AMENDMENT C243 TO THE HUME  
PLANNING SCHEME:

# SUNBURY SOUTH AND LANCEFIELD ROAD INFRASTRUCTURE CONTRIBUTIONS PLAN

## URBAN DESIGN - EXPERT WITNESS STATEMENT

23<sup>RD</sup> OCTOBER 2020

PROJECT SUNBURY STH AND LANCEFIELD RD PSP			
JACKSON CREEK BRIDGE (SS-SD1) ALTERNATIVE LONG OPTION GENERAL ARRANGEMENT SHEET 1			
PROJECT NO. 2113308A	DISCIPLINE - STR -	NUMBER 0102	REV. A

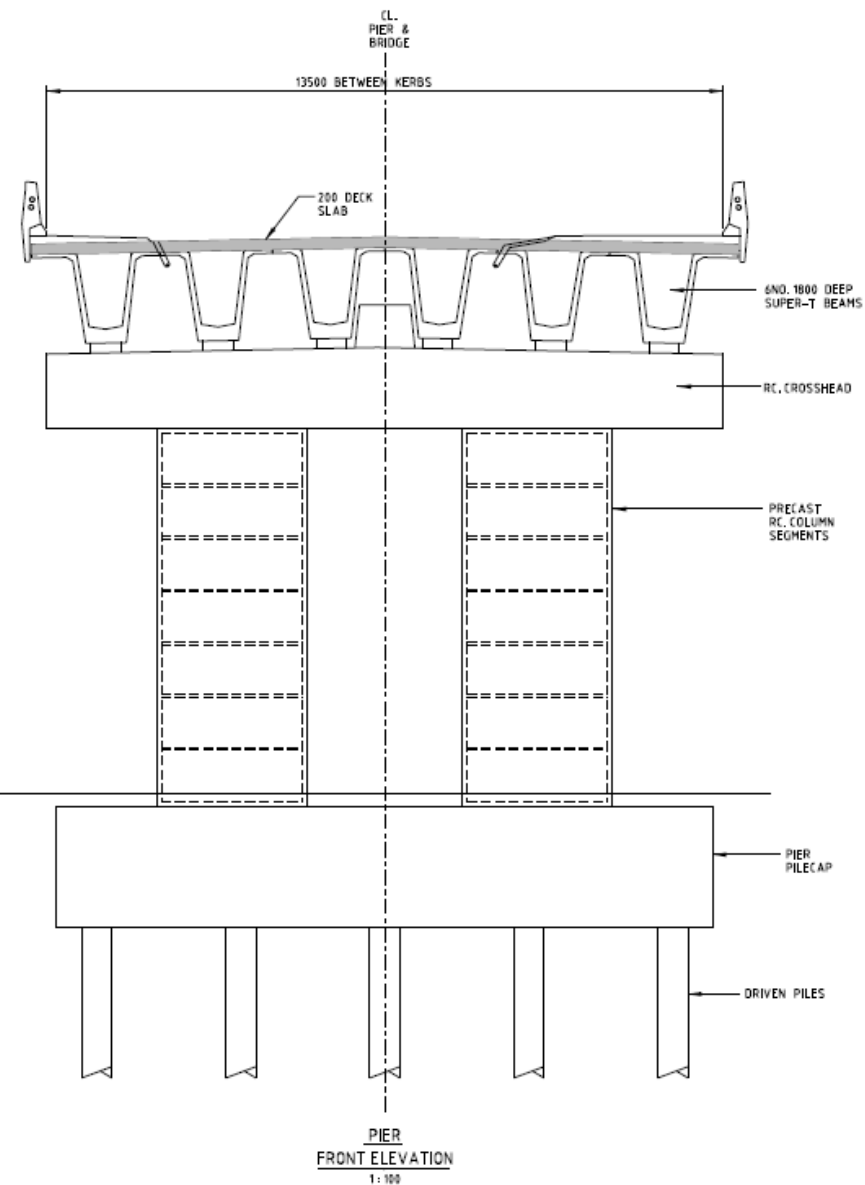
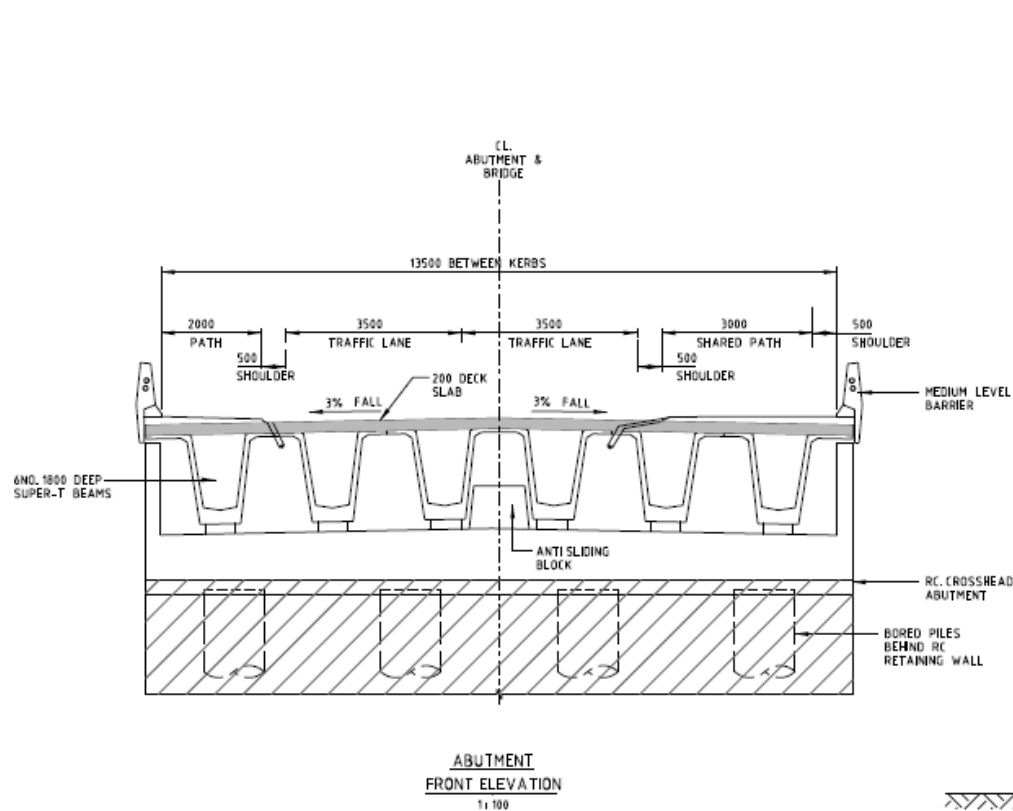
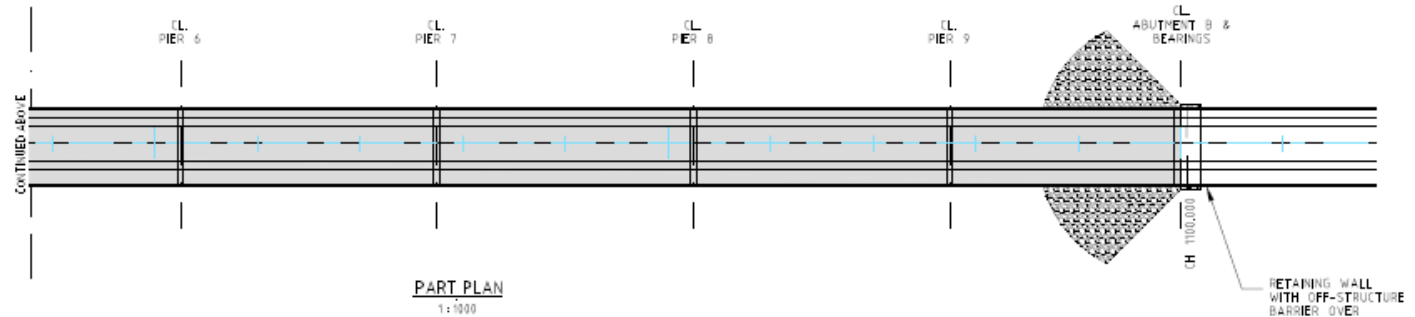
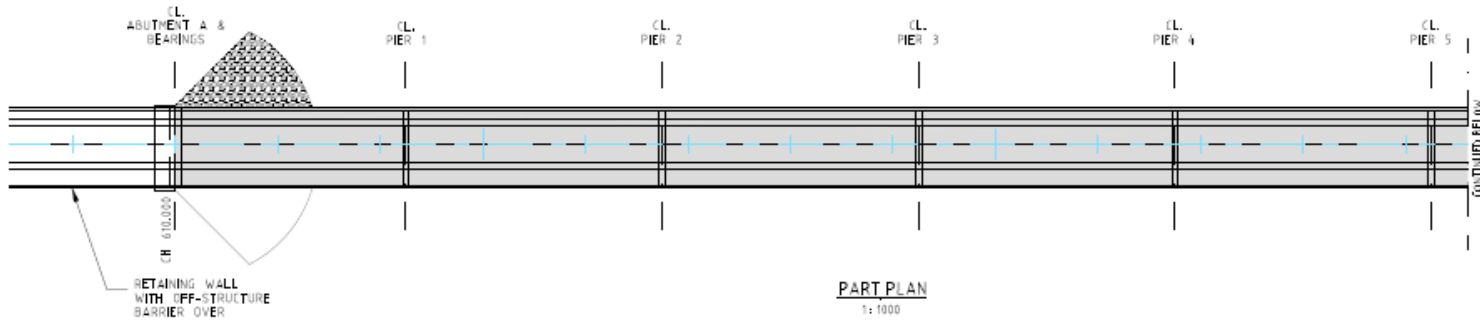
This option comprises all concrete construction, featuring eight sets of twin piers, 35 m apart, supporting a separate crosshead, which in turn supports five beams.

The total bridge deck length is 315 m

The total deck depth, from top of crash barrier to underside of the beams is approximately 3 m.

The crosshead visually interrupts the line of the bridge soffit and the multiple angular beams create visual clutter and shadowing.

The twin sets of piers located at relatively close centres results in a cluttered and inelegant effect in views towards the bridge and from under the bridge when viewed along the alignment of the bridge.

The relative shallowness of the bridge deck is offset by the exposed cross heads and closely spaced piers.

Project	SUNBURY STH AND LANCEFIELD RD PSP
Title	JACKSON CREEK BRIDGE (LR-BR-01)
	ALTERNATIVE LONG OPTION 3
	GENERAL ARRANGEMENT SHEET 2
Project File	A3
Drawing No:	2113308A-STR-0402
Rev.	C

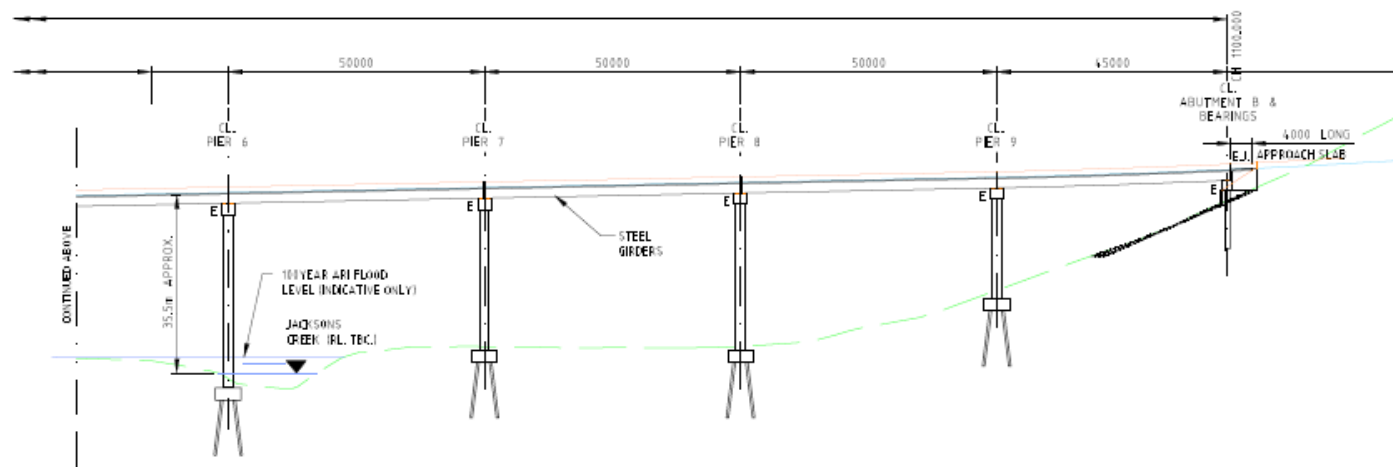
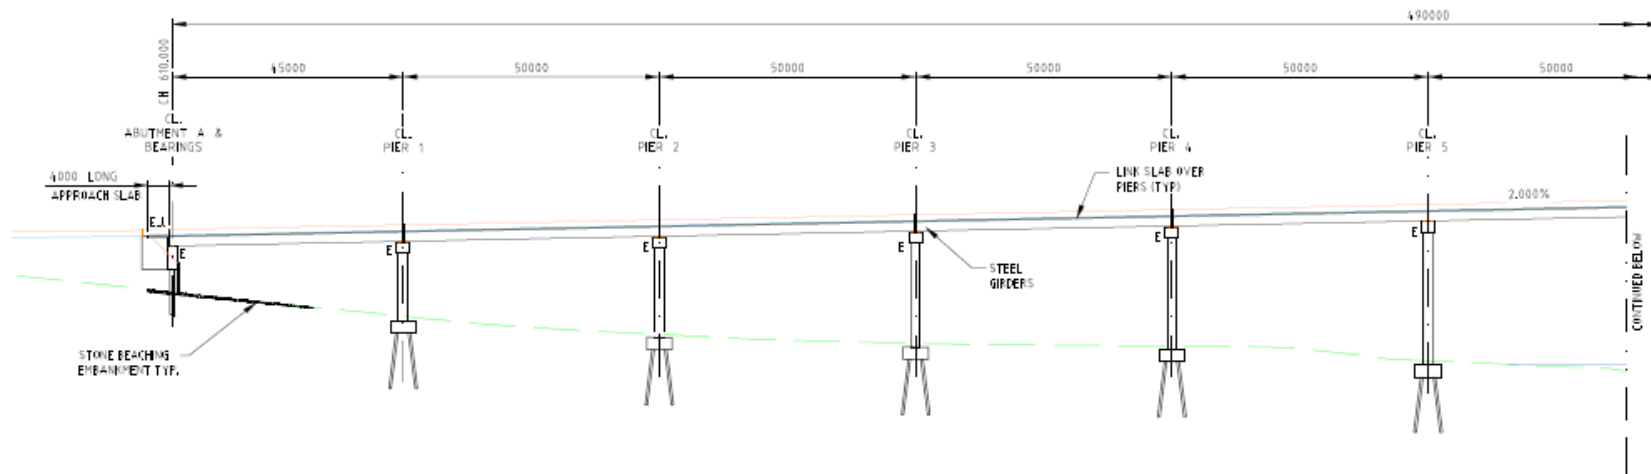
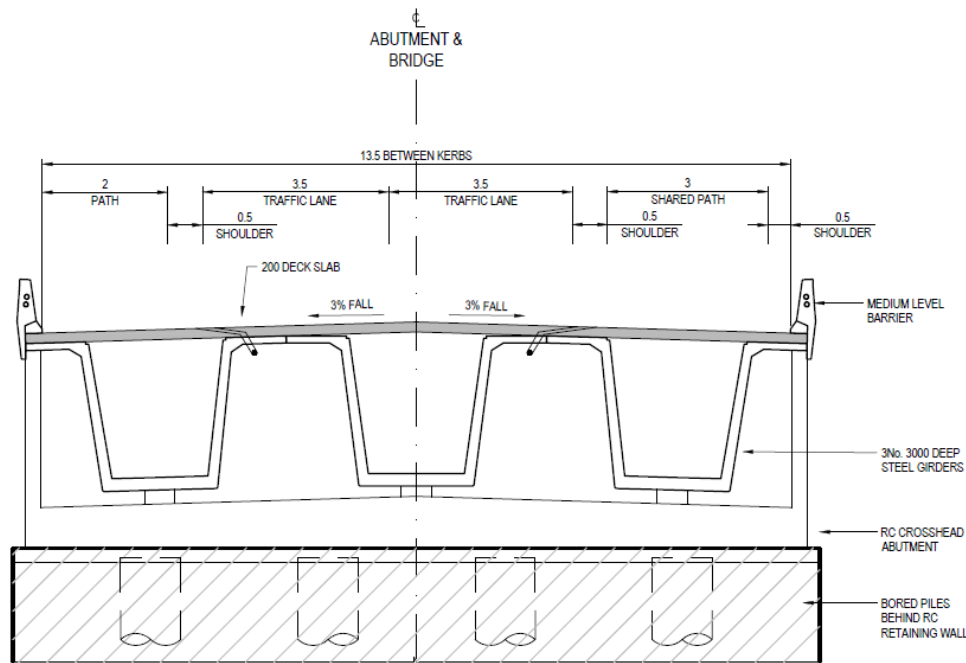
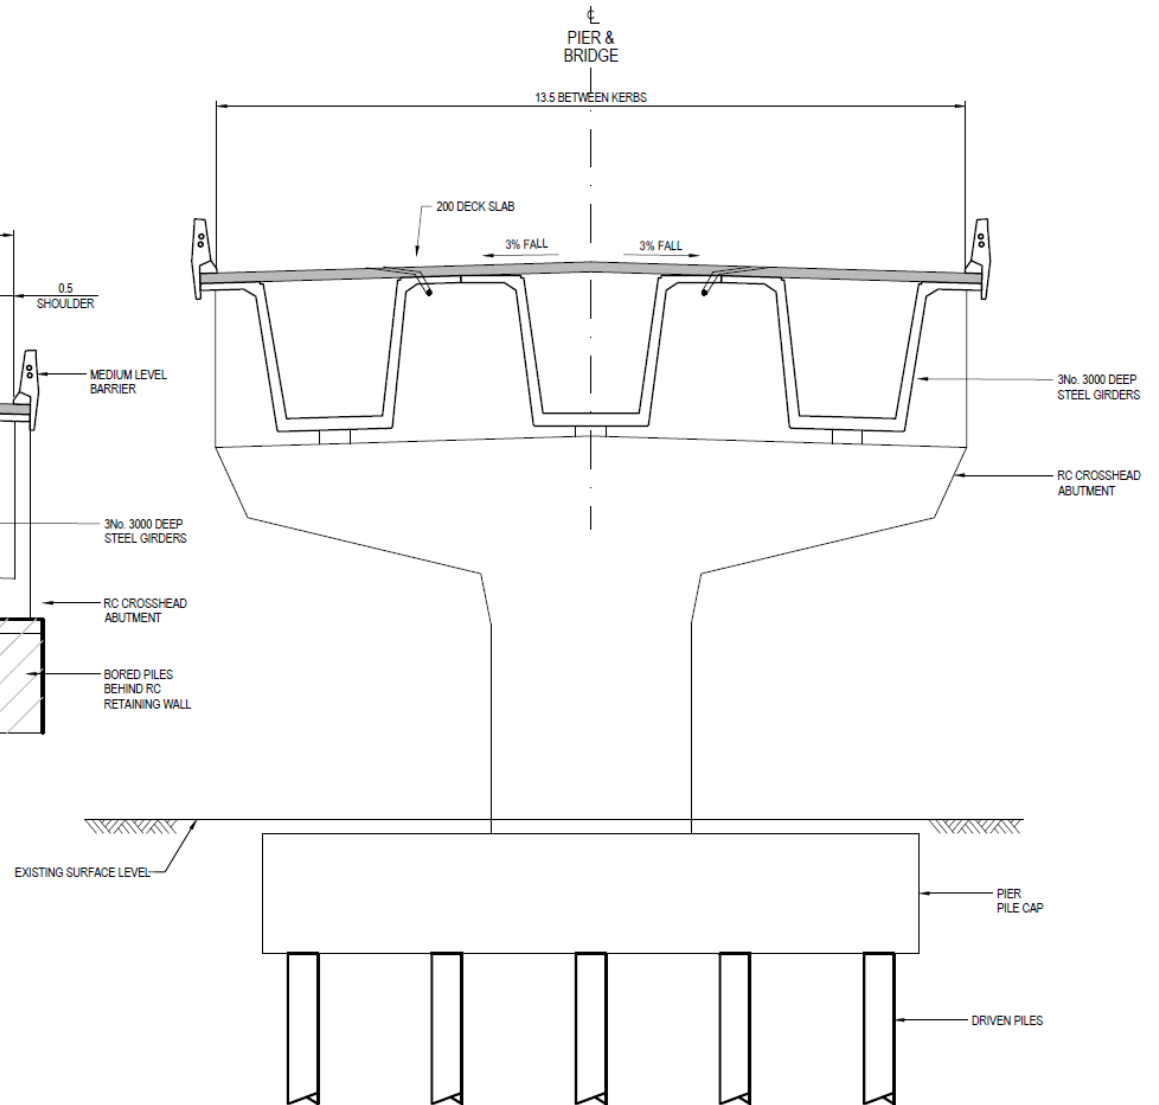
This option is a combination of concrete and steel construction. It features nine singular blade piers, 45 m from the abutments at the bridge ends and 50 m apart, supporting three girders.

The total bridge deck length is 490 m.

Total deck depth, from top of crash barrier to underside of the girders is slightly deeper than the Alternative Option due to the additional depth of the fewer number of girders over the more numerous concrete beams.

The three girders, tapered in section, along with the lack of crossheads, result in a cleaner soffit line and less visually cluttered and shadowed underside.

It is my opinion that the slightly deeper deck is not a significant factor given the length of the bridge

Option 3 is very similar in concept to the new Chandler Highway bridge (refer to **Figure 9**).

As a result of my assessment, it is my opinion that Alternative Option 3 is the most suitable design for the scenic quality of the setting of the Jacksons Creek valley.
